PCN# 20250404000.1

**Qualification of LFAB as an additional Wafer Fab site option for select devices
Change Notification / Sample Request**

PCN Number:	20250404000.1	PCN Date:	April 04, 2025
Title:	Qualification of LFAB as an additional Wafer Fab site option for select devices		
Customer Contact:	Change Management Team	Dept:	Quality Services
Proposed 1st Ship Date:	July 03, 2025	Sample requests accepted until:	June 03, 2025*
*Sample requests received after June 03, 2025 will not be supported.			
Change Type:			
<input type="checkbox"/> Assembly Site	<input checked="" type="checkbox"/> Design	<input type="checkbox"/>	Wafer Bump Material
<input type="checkbox"/> Assembly Process	<input type="checkbox"/> Data Sheet	<input type="checkbox"/>	Wafer Bump Process
<input type="checkbox"/> Assembly Materials	<input type="checkbox"/> Part number change	<input checked="" type="checkbox"/>	Wafer Fab Site
<input type="checkbox"/> Mechanical Specification	<input type="checkbox"/> Test Site	<input type="checkbox"/>	Wafer Fab Material
<input checked="" type="checkbox"/> Packing/Shipping/Labeling	<input type="checkbox"/> Test Process	<input checked="" type="checkbox"/>	Wafer Fab Process

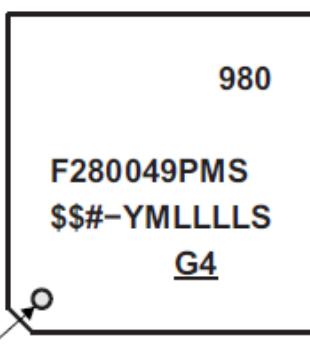
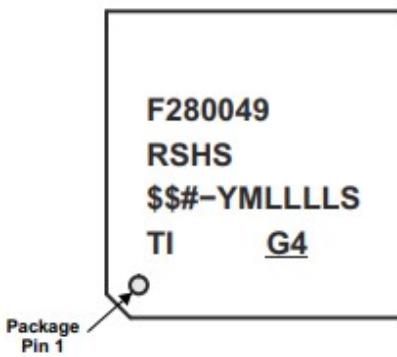
Changes to product identification resulting from this PCN:

Original Wafer Fab Code:

\$\$ = YF → TSMC-F14

Updated Wafer Fab Code:

\$\$ = 3L → LFAB

Original Silicon Revision Code:

Updated Silicon Revision Code:

= D
